**EAST HARTFORD-GLASTONBURY
ELEMENTARY MAGNET SCHOOL PHASE 2
GLASTONBURY, CONNECTICUT
STATE PROJECT NOS. 054-0095 MAG/N/PS & 054-0096 MAG/N/PS
GLASTONBURY BID NO. GL-2011-04**

The following changes to the Drawings and Project Manual shall become a part of the Contract Documents superseding previously issued Drawings and Specifications to the extent modified by this Addendum No. 3. Bidders shall ensure this addendum is acknowledged in the appropriate space provided on the Bid Form when submitting their bid.

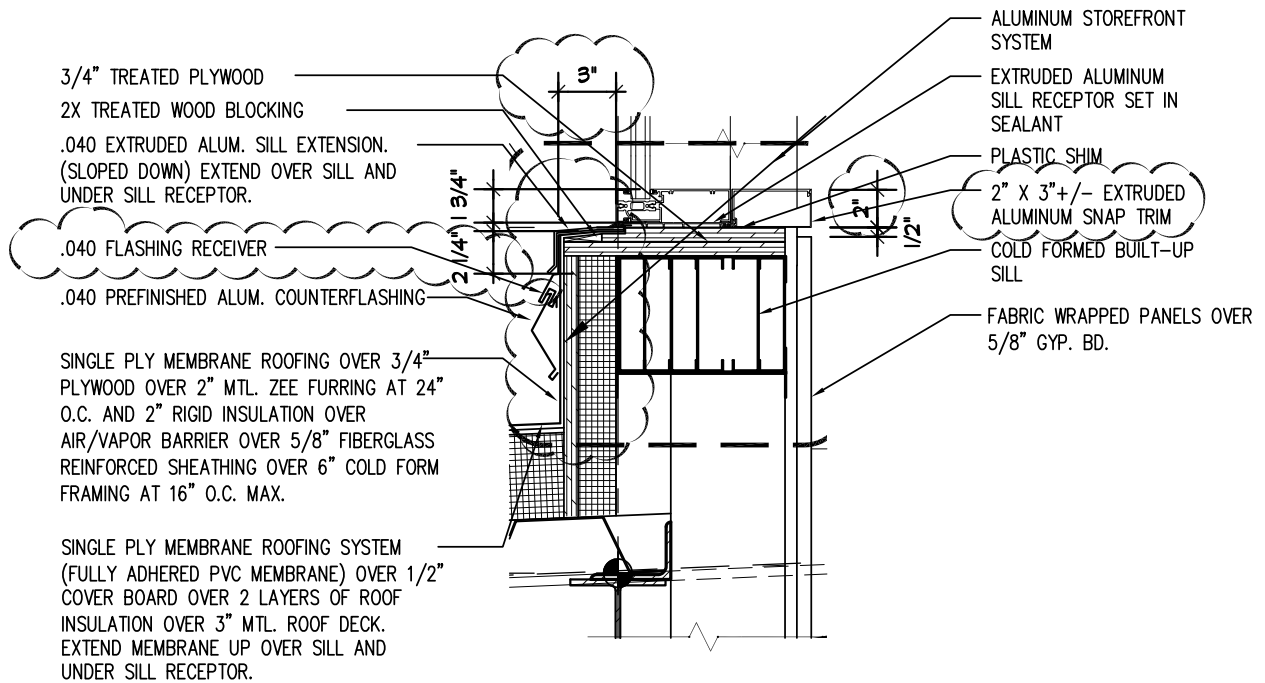
QUESTION: Drawing A821, Details 14, 16, 17 & 18: Confirm all fabric tack surfaces at millwork/casework are by BP -108.

RESPONSE: Drawing A-821, Details 14, 16 & 18, Fabric Tack Surfaces at millwork/casework shall be provided by BP-108 Architectural Millwork/Casework.

FLETCHER THOMPSON ELEVATING DESIGN SHAPING SOLUTIONS ARCHITECTURE ENGINEERING INTERIOR DESIGN THREE CORPORATE DRIVE SHELTON, CONNECTICUT 06484-6244	PROJECT TITLE: EAST HARTFORD GLASTONBURY	DATE: 1/31/11
	DRAWING TITLE: RE: 2/A443	PROJECT NO.: H090230.000
DRAWN BY: GCC	SCALE: NTS	DWG. NO.: SKA-001

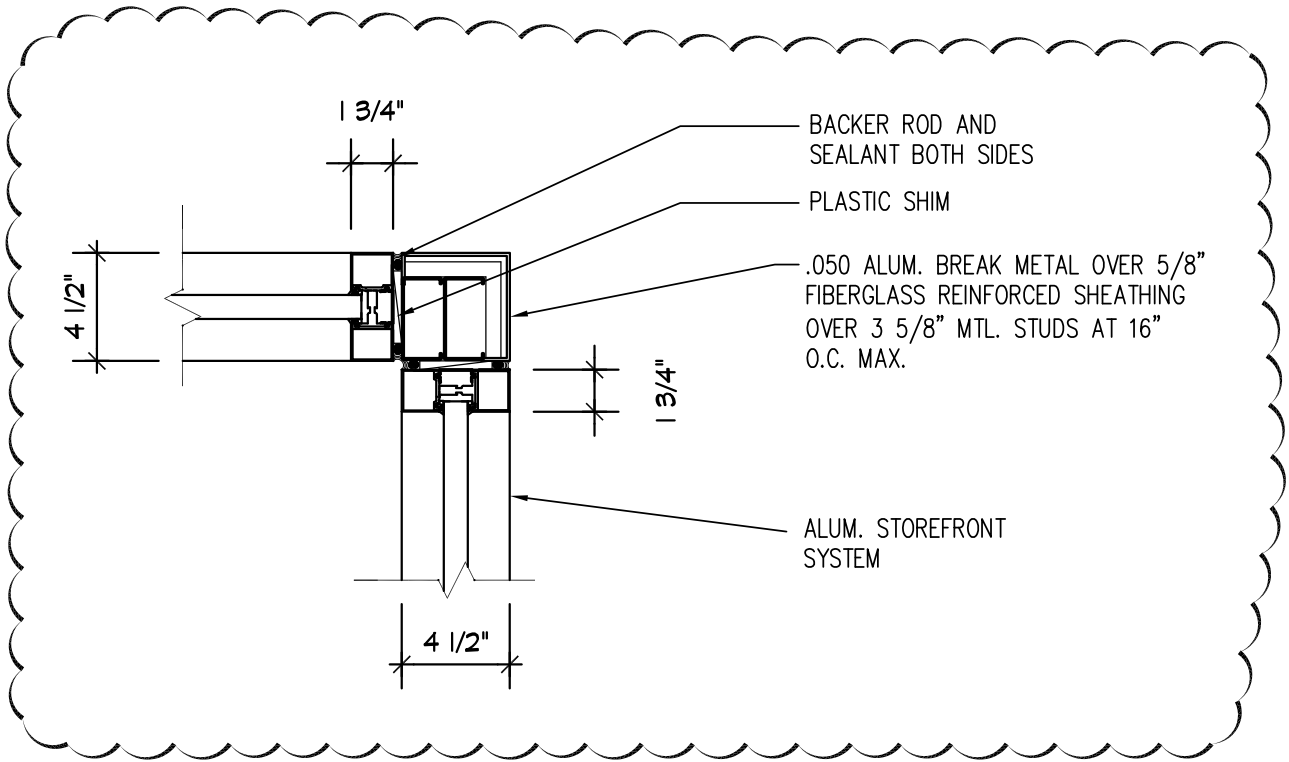
- 1) CLARIFICATION: On Drawing No. A-443, Detail 2, some of the graphics in the detail did not print. Refer to the attached copy of revised Sketch No. SKA-001 dated 1/31/11.
- 2) On Drawing No. A-443, Detail 13, REVISE the corner detail to make the corner enclosure the correct size as indicated on attached copy of Sketch No. SKA-002 dated 1/31/11.

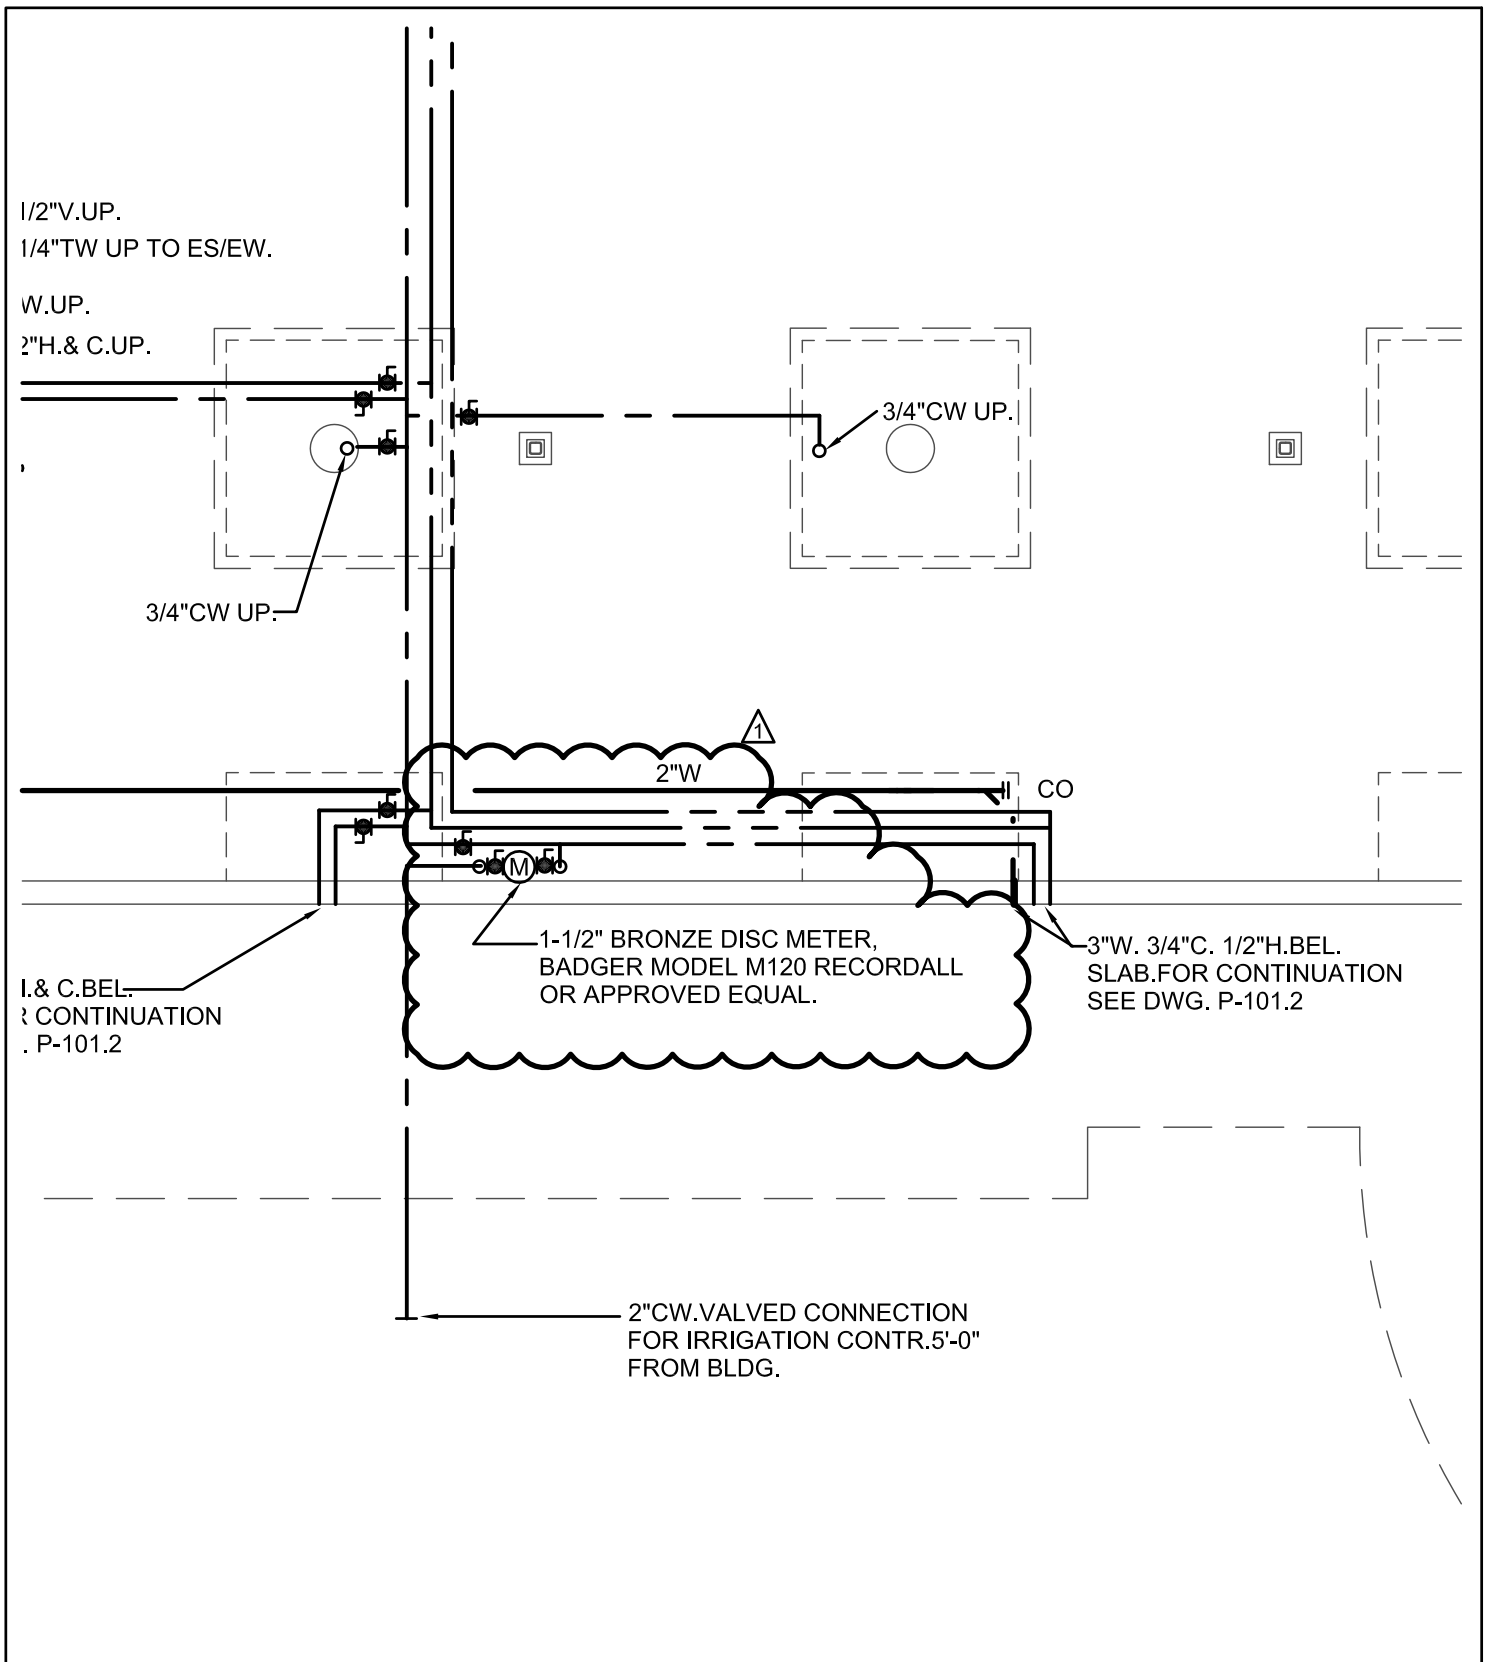
- 1) CLARIFICATION: On Drawing No. A-442, Detail 5, the partition type below the sill of Window Type W-40 is 8" CMU and not gypsum board and metal stud as shown on Detail 5/A442. Refer to attached copy of Sketch No. SKA-004 dated 1/31/11.

RESPONSE: The low partition support was incorrectly referenced from Detail 5 on Drawing A442. We revised this detail to reflect the correct 8" CMU low partition under the sill at W-40 therefore the low partition support is not required at this location. Refer to the attached SKA-004.
